HFE20-1

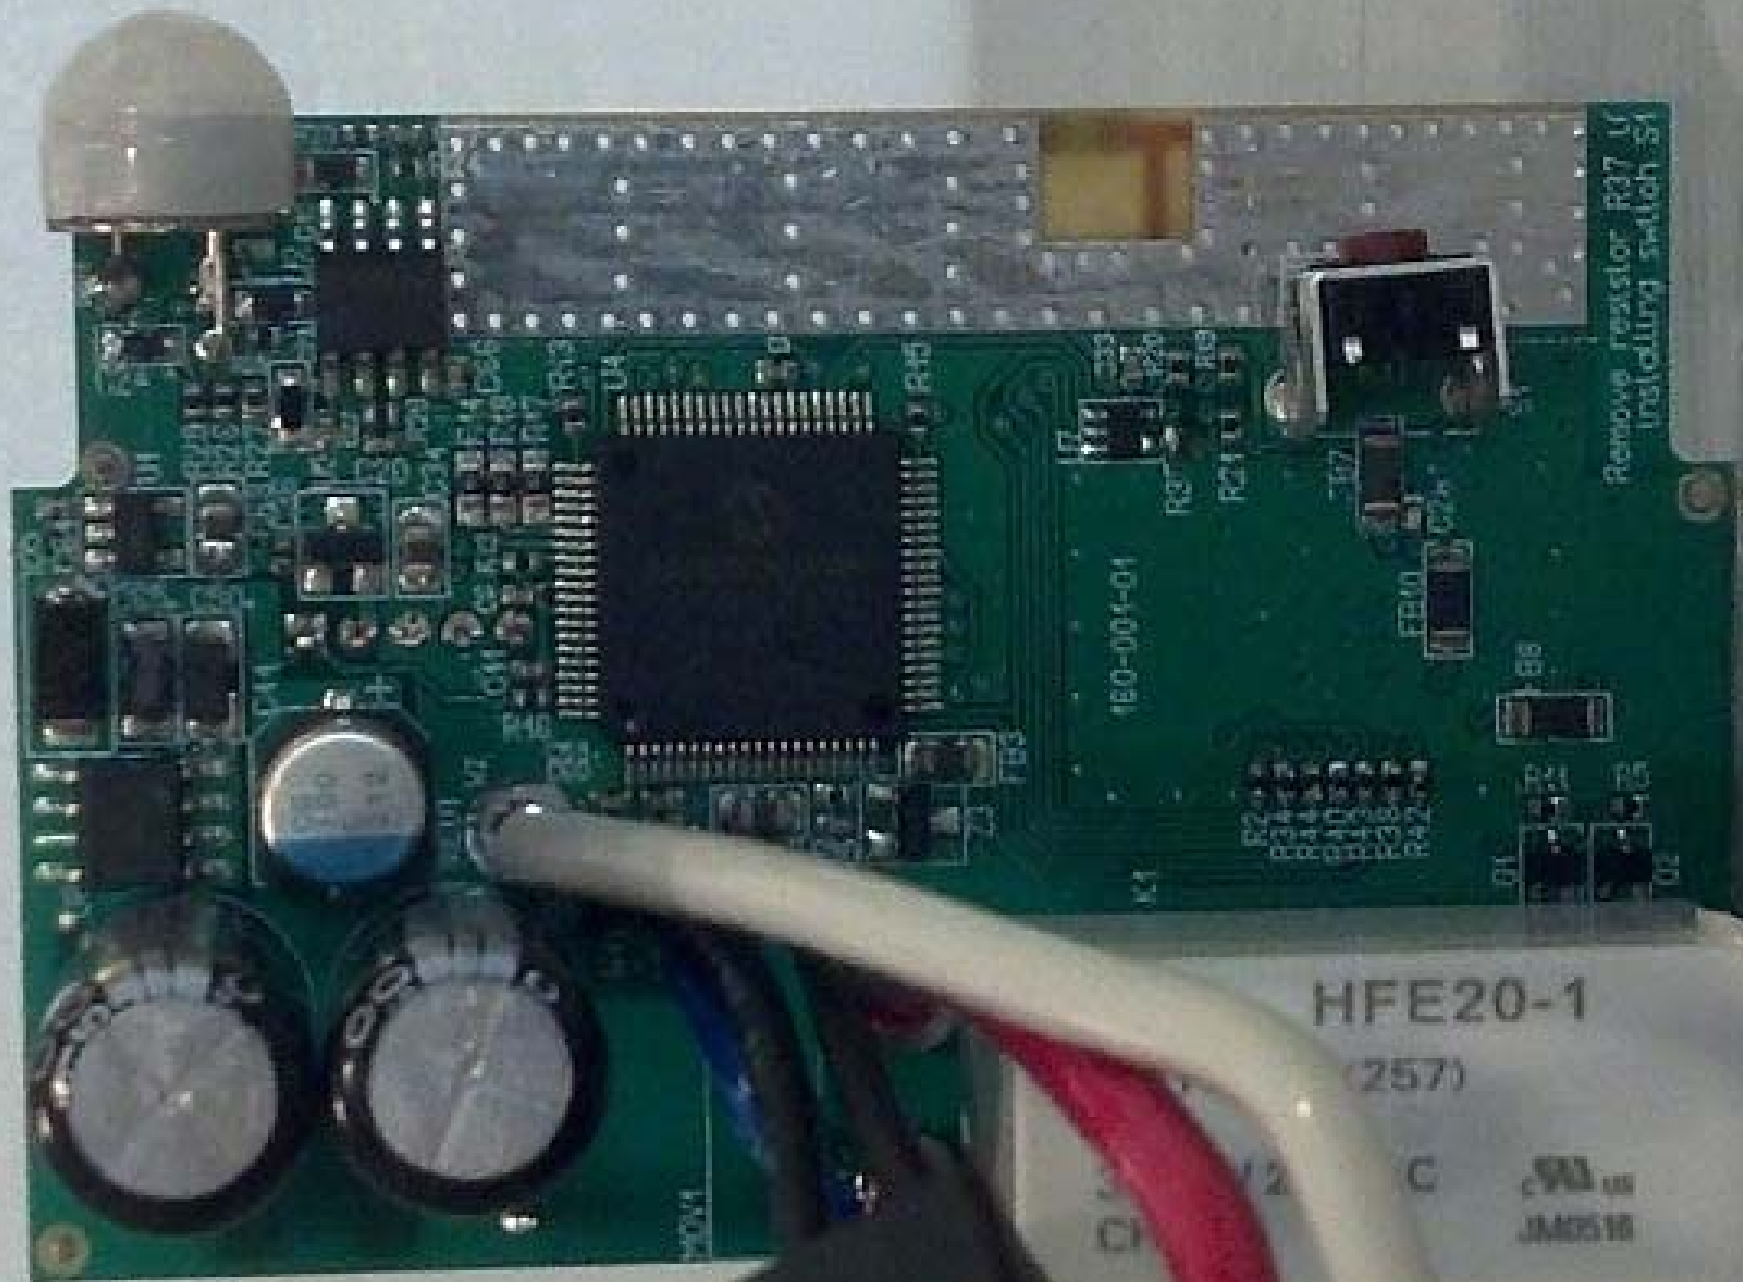
Remove resistor R37 if
installing switch S1
